# **Kozlowski Floodprone Properties Assistance Program Letter of Map Revision**

## **Wittmann Area, Maricopa County**

### **Technical Data Notebook**

Date: January 4, 2012  
To: Syed Qayum, LOMR Technical manager – BakerAECOM  
From: Brian Wahlin, Project Manager – WEST Consultants, Inc.  
Riley Asburry – WEST Consultants, Inc.  
Re: Response to Comments for the Kozlowski FPAP

Figure 3. 1-foot and 2-foot contours.

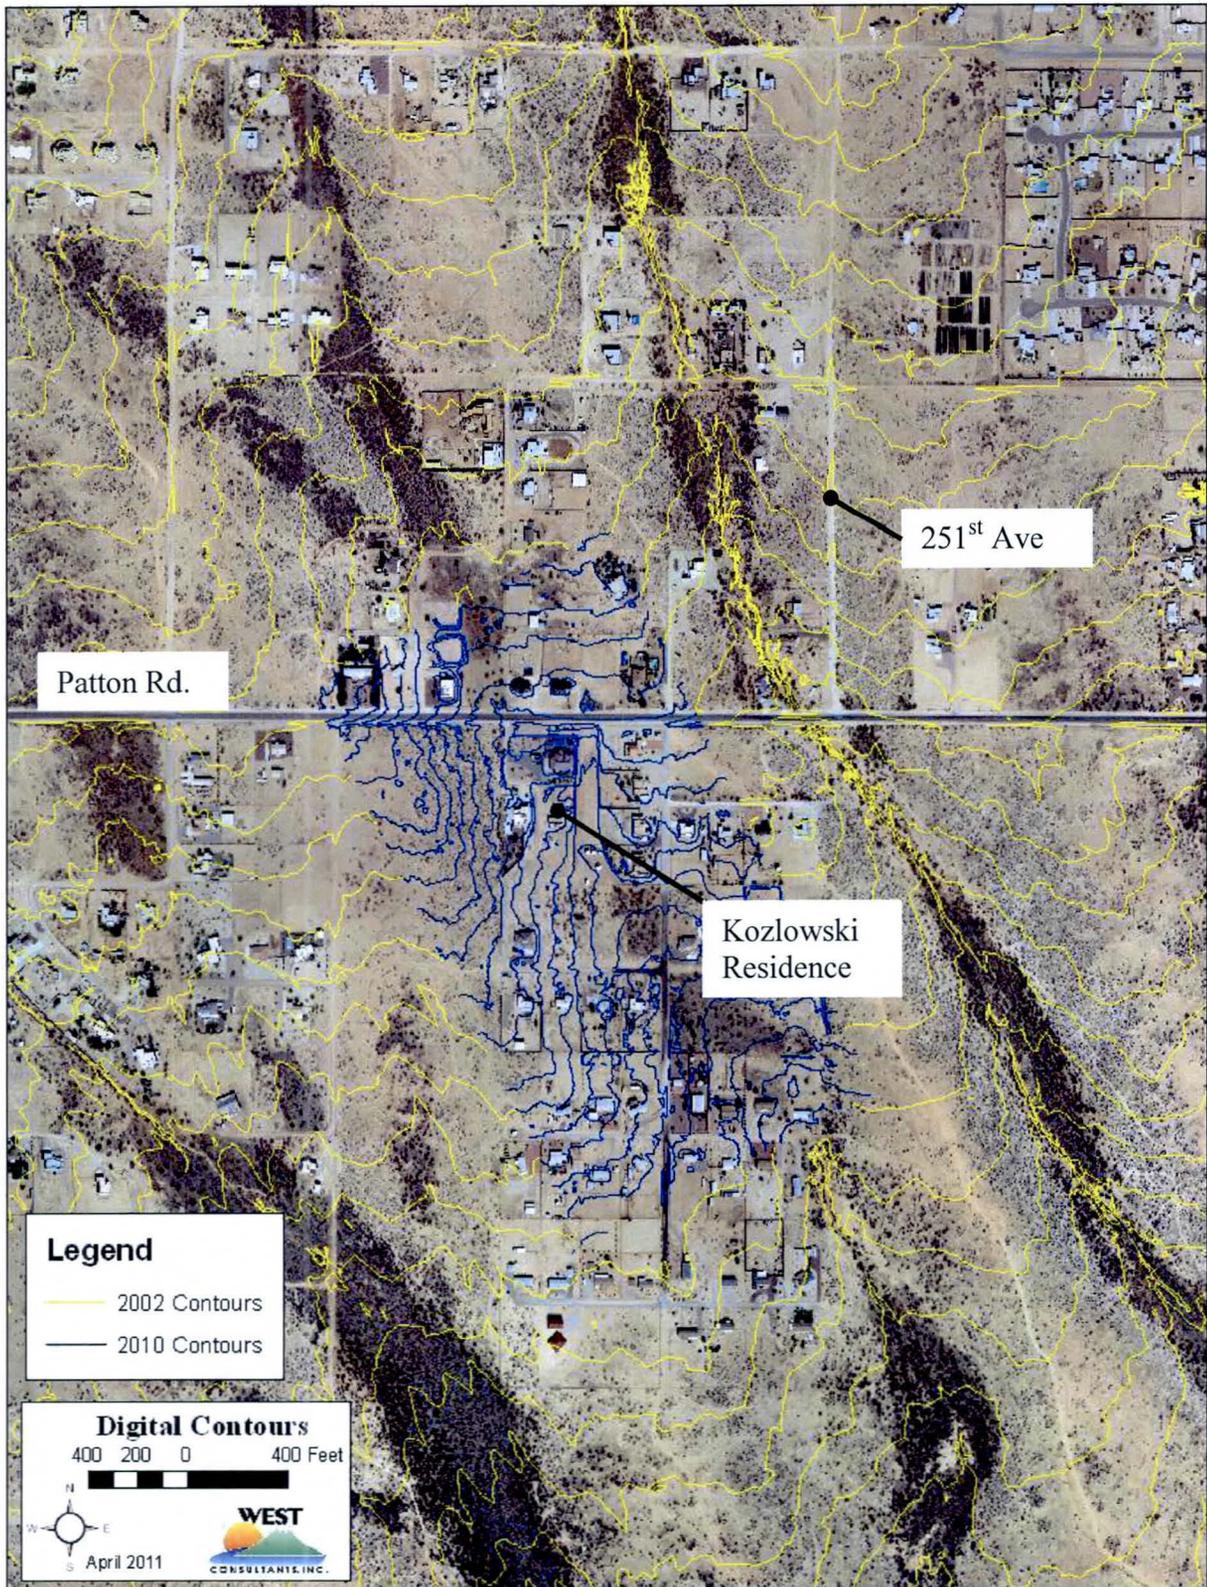
For reference I suggest labeling a couple of roads and calling out the Kozlowski property on Figure 3.

For reference I suggest labeling a couple of roads and calling out the Kozlowski property on Figure 3.

RS = 1.891

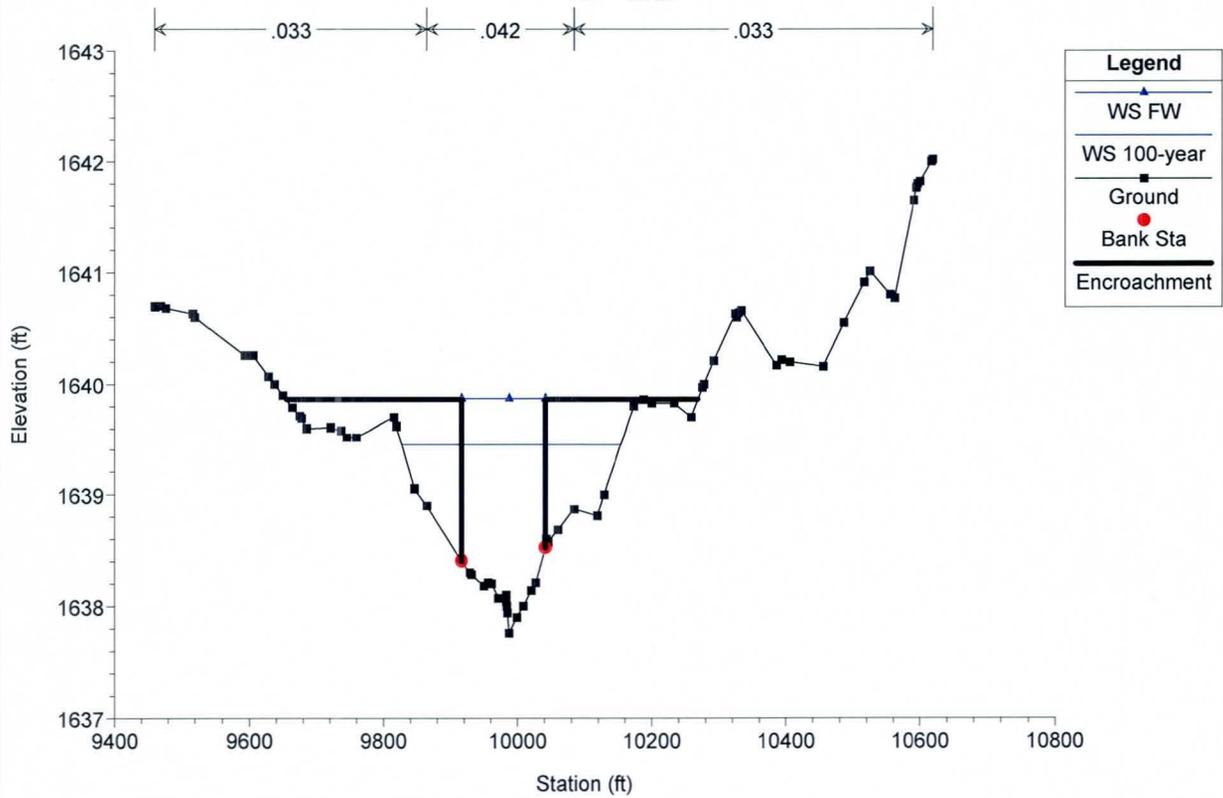
4. The base (1-percent-annual-chance) floodplain top widths shown in the existing conditions HEC-RAS hydraulic analysis at cross sections 1.604, 1.803, 1.891, and 2.476 do not match the approximate base floodplain top widths shown on the submitted topographic work map entitled, "Wash T4N-R3W-S08W Kozlowski Floodprone Properties Assistance Program," prepared by WEST Consultants, Inc., dated September 2011. Please provide an explanation for these discrepancies, or make the appropriate changes.

**WEST Response: The levee option has been removed from this cross section and has been replaced with an ineffective flow area option.**
4. The base (1-percent-annual-chance) floodplain top widths shown in the existing conditions HEC-RAS hydraulic analysis at cross sections 1.604, 1.803, 1.891, and 2.476 do not match the approximate base floodplain top widths shown on the submitted topographic work map

entitled, "Wash T4N-R3w-S08W Kozlowski Floodprone Properties Assistance Program," prepared by WEST Consultants, Inc., dated September 2011. Please provide an explanation for these discrepancies, or make the appropriate changes.

**WEST Response:** The approximate base floodplain top width have been adjusted on the workmaps to more closely match the approximate base floodplain top widths shown in the hydraulic analysis.
